GS# 103-317
University Pointe – Buildings 100 & 200
Jackson State University
Project Number: 2017-006

Addendum No. 2

14May2026

1 1/2" = 1'-0"

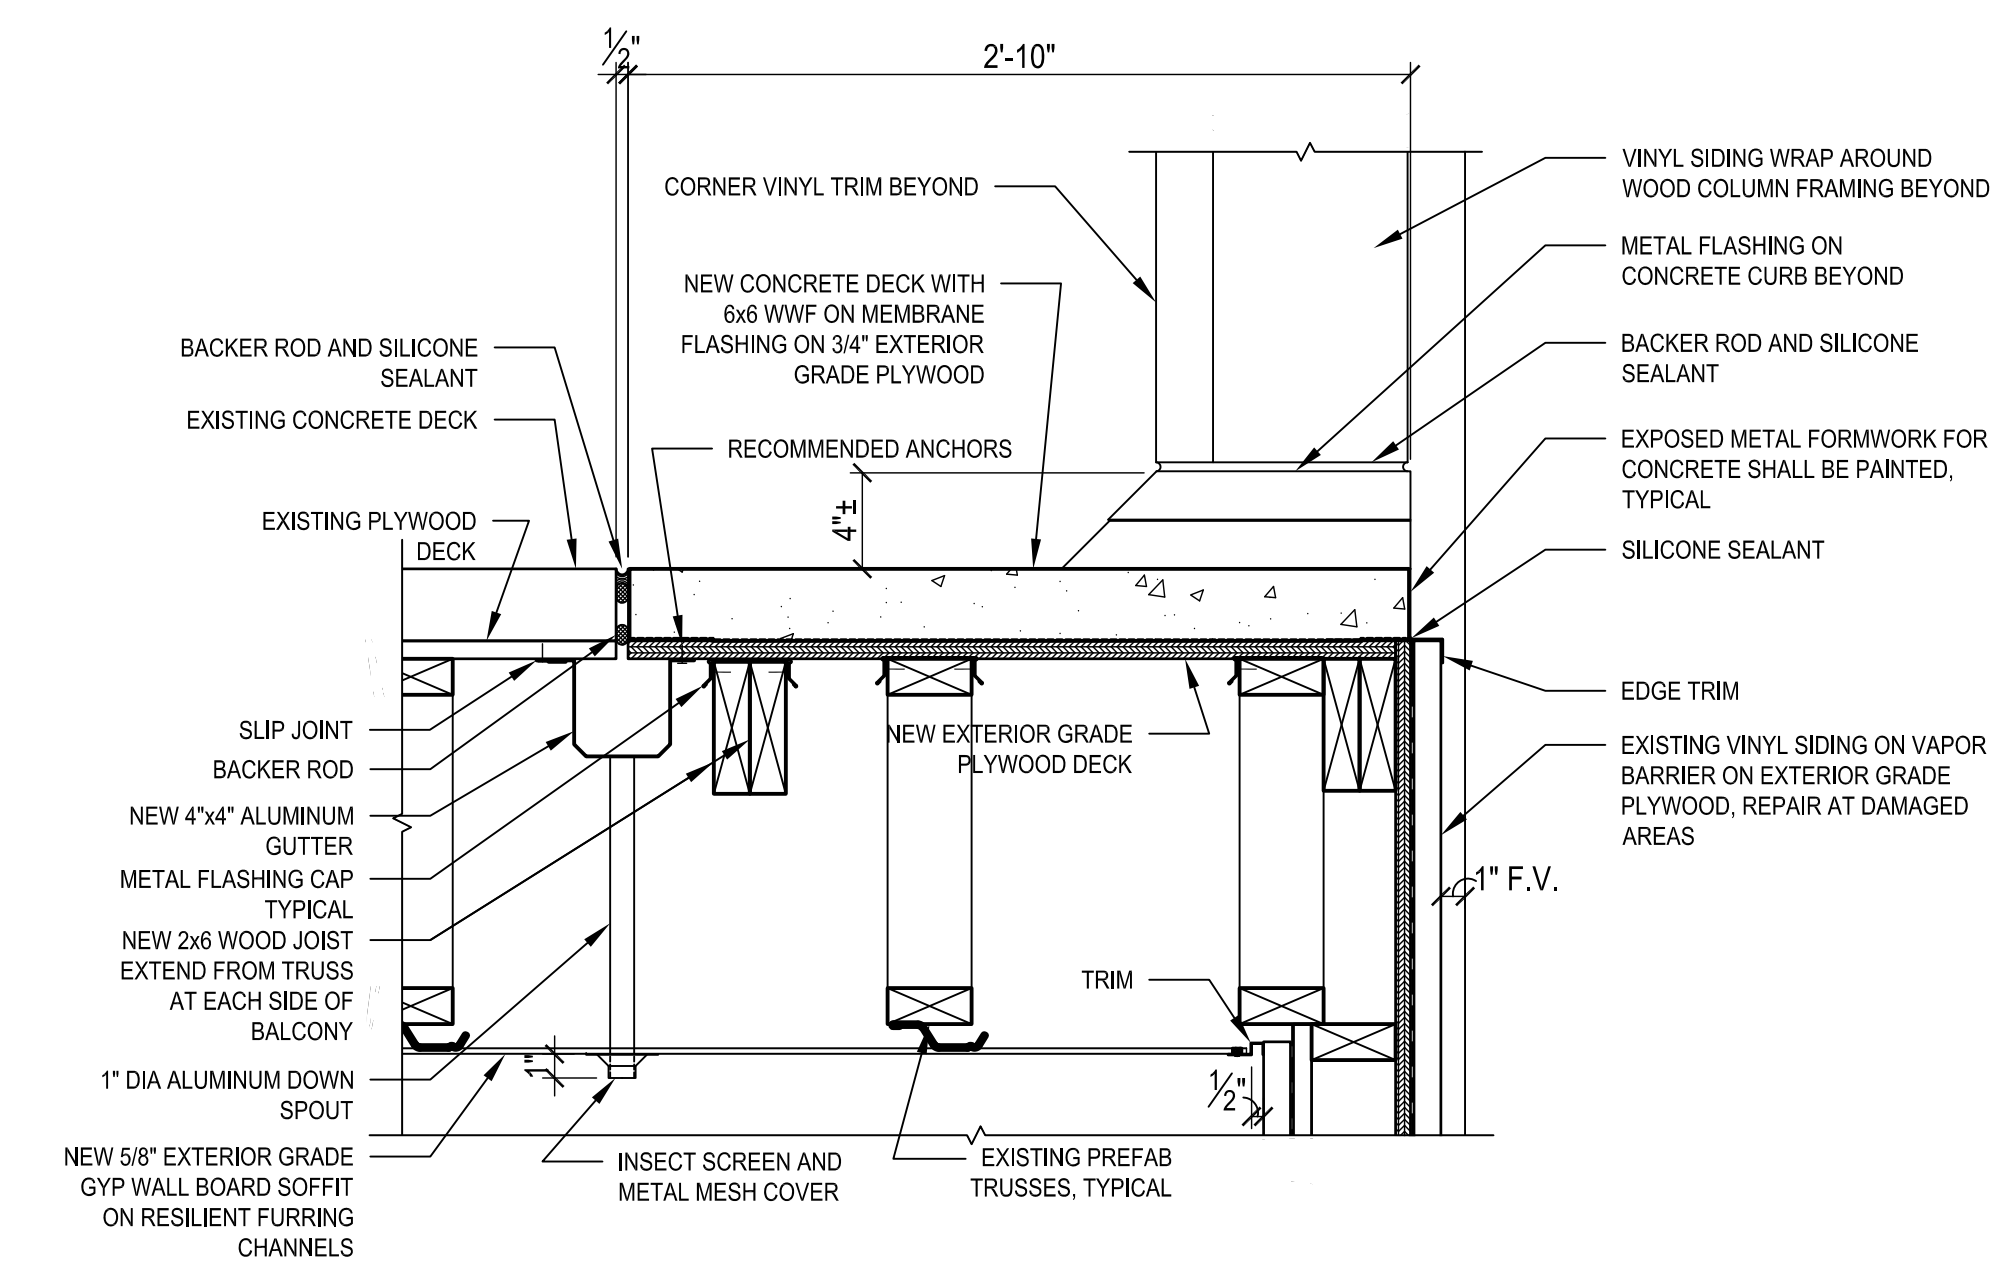
- Response: Yes. Remove all of the existing insulation and install new insulation. Current code mandated "R" values and STC ratings shall apply.
- Item No. 17 Water damage was observed at the west balconies of Building 200 (see attached photos). The plans do not indicate work to be performed at these locations or the extent to be done. One location where the soffit was removed you could clearly see rot and damage to the floor decking above and the wall studs. Repairing this particular location would require removing the concrete topping on the balcony above to replace the substrate. It is unknown if this would be required or not at the other locations or if the floor trusses might need repaired at the other locations. Please clarify what is to be done at these locations.

- Response: Details which will be representative of the as-built conditions are provided as part of this addendum (drawing sheet A-502). The soffits are to be removed in their entirety and replaced. The concrete decks shall be cut and removed per the details. Damaged OSB sheathing, vapor barrier and plywood and 2"x framing shall be replaced. Damaged wood decking and vertical sheathing shall be replaced with exterior grade plywood with a membrane waterproofing barrier applied between substrate decking and new concrete (install 6x6 WWF in the new concrete). Install supplemental wood framing at the trusses as needed to maintain stability.

- Retrofit work shall be applied at **all** balconies (east and west facades) for the second and third floors.
- Alternate balcony concrete substrate: Galvanized (9/16" thick) Type "S" Form Deck – 26 gauge. Submit cost difference for comparison.

- NOTES:
- 1) REMOVE THE EXISTING CONCRETE TO THE LIMITS SHOWN AS A MINIMUM TO PROVIDE ACCESS TO THE COMPROMISED WOOD FRAMING. REPLACE THE DAMAGED 2"x FRAMING AND REPLACE USING PRESSURE TREATED LUMBER TO MATCH THE EXISTING SIZES.
 - 2) APPLY 2x4 AND 2x6 WOOD LUMBER TO SUPPLEMENT THE PRE-ENGINEERED TRUSSES IF FOUND TO BE COMPROMISED.
 - 3) REMOVE THE EXISTING EXTERIOR SOFFIT IN ITS ENTIRETY. INSTALL A NEW GYP WALL BOARD EXTERIOR SOFFIT. APPLY PRIMER COAT OF PAINT AND NEW PAINT FINISH.
 - 4) MATCH THE THICKNESS OF ALL MATERIAL TO BE REPLACED.
 - 5) REMOVE DAMAGED SHEATHING AND REPLACE WITH NEW SHEATHING WITH VAPOR BARRIER.
 - 6) REMOVE THE CORNICE AT THE SECOND FLOOR BALCONY TO MAKE THE REPAIRS FOR THE FRAMING, SHEATHING AND VAPOR BARRIER. RECONSTRUCT THE CORNICE, SEE DETAIL 3/A-501 AS EXAMPLE OF THE TYPICAL CONDITION.

- NOTES:
- 1) REMOVE THE EXISTING CONCRETE TO THE LIMITS SHOWN AS A MINIMUM TO PROVIDE ACCESS TO THE COMPROMISED WOOD FRAMING. REPLACE THE DAMAGED 2"x FRAMING AND REPLACE USING PRESSURE TREATED LUMBER TO MATCH THE EXISTING SIZES.
 - 2) APPLY 2x4 AND 2x6 WOOD LUMBER TO SUPPLEMENT THE PRE-ENGINEERED TRUSSES IF FOUND TO BE COMPROMISED.
 - 3) REMOVE THE EXISTING EXTERIOR SOFFIT IN ITS ENTIRETY. INSTALL A NEW GYP WALL BOARD EXTERIOR SOFFIT. APPLY PRIMER COAT OF PAINT AND NEW PAINT FINISH.
 - 4) MATCH THE THICKNESS OF ALL MATERIAL TO BE REPLACED.
 - 5) REMOVE DAMAGED SHEATHING AND REPLACE WITH NEW SHEATHING WITH VAPOR BARRIER.
 - 6) REMOVE THE CORNICE AT THE SECOND FLOOR BALCONY TO MAKE THE REPAIRS FOR THE FRAMING, SHEATHING AND VAPOR BARRIER. RECONSTRUCT THE CORNICE, SEE DETAIL 3/A-501 AS EXAMPLE OF THE TYPICAL CONDITION.
